Planning Board and City Council  
City of Newburyport, Massachusetts  
*by email*

Memo: Urban Design Critique of Waterfront West

*Marked in black are the street edges currently lacking spatial definition.*

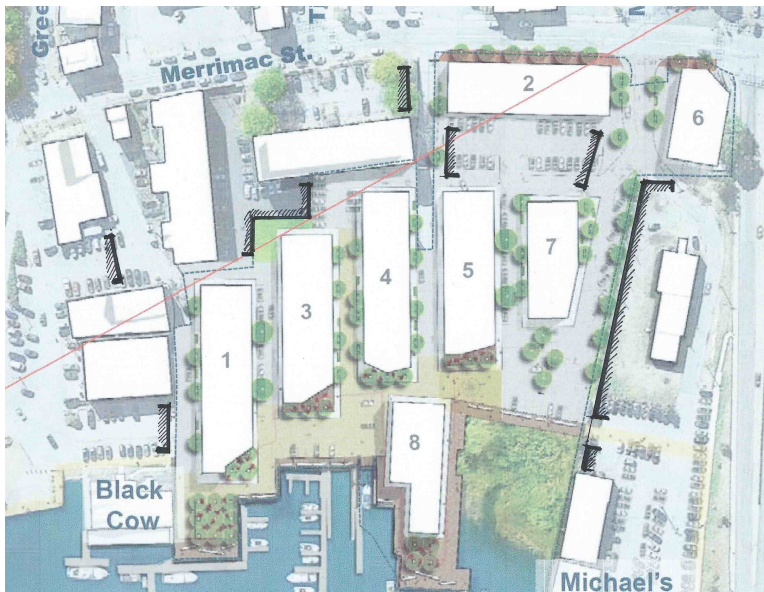
One need only walk west on Merrimac Street to recognize how the pedestrian experience deteriorates rapidly west of Green Street, where the street wall disappears and buildings have been allowed to sit behind their parking lots. In addition to eroding the spatial quality of the street, these front parking lots send the message that the neighborhood

As noted above, the current scheme suffers from a lack of well-shaped street edges in a number of locations. Some are more problematic than others, like the central entrance alongside the unfortunate parking lot to the east (left) of the hotel (Building 2). The worst by far is the long exposed parking area to the west (right). It only makes sense to maintain a street in this location if the site to its west is expected to be redeveloped soon.

Easier to fix is the parking lot behind the hotel, which damages the experience of two of the three project entrances. At the very least, these edges should be well lined by walls and greenery, but it would be better if a plan reconfiguration were to eliminate this gap entirely.

*The elevation shown at right is the landward face of Building 8, which terminates the central spine with garage doors and shuttered openings.*

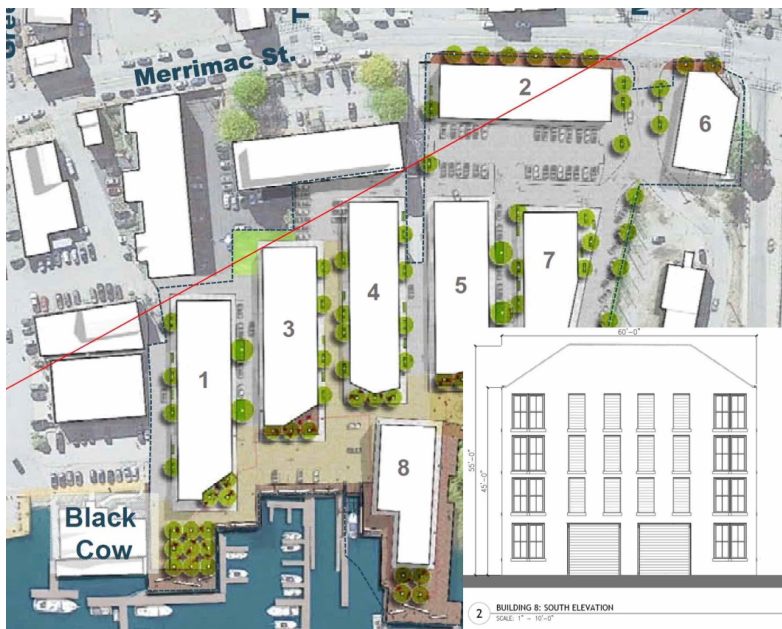
Of particular note in this regard is Building 8, which appears to terminate the view down the central spine with a façade that is not worthy of its key location. This façade needs reconsideration.

*One possible redesign of the current plan converts three of the current drivable thoroughfares to non-driving use.*

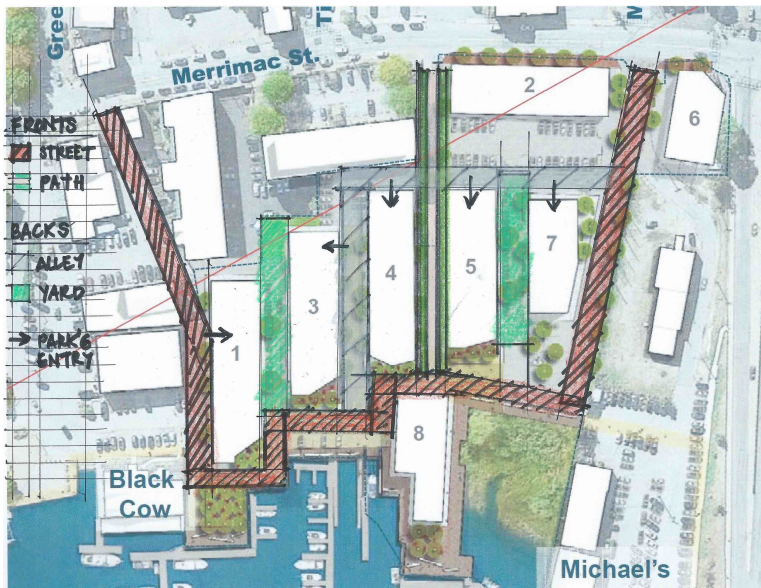
Additionally, this conception of the plan, in which each narrow building is treated like a city block, results in an excessive amount of driving infrastructure. Traditionally, most city blocks have buildings on both edges, with either rear yards or an alley at the center.

Rarely in such blocks are there also drives through the middle of each building, as happens here, to serve parking. Remarkably, the combination in this proposal of streets, alleys, and internal parking drives around and through every building results in an astounding *eleven* distinct north-south driving paths in only 500 feet of site.

This solution, in which the entire ground plane is essentially drivable, seems unnecessary. It allows fire trucks to access both sides of all buildings, something that few cities require. After all, most American buildings have rear yards, not rear drives.

An alternative proposal for the same plan imagines the site as two blocks rather than five. It allows the central spine to be pedestrian only—making it easier to elevate to first-floor level—and places only one alley between buildings, allowing the others to be turned into rear yards. Beyond its parking entry (see below), this alley may not even be needed. A plan such as this one would take pressure off the non “front” faces of the buildings, so that activity, detail, and budget could be focused in the places where people are likely to walk, drive, and otherwise spend time in the public realm.
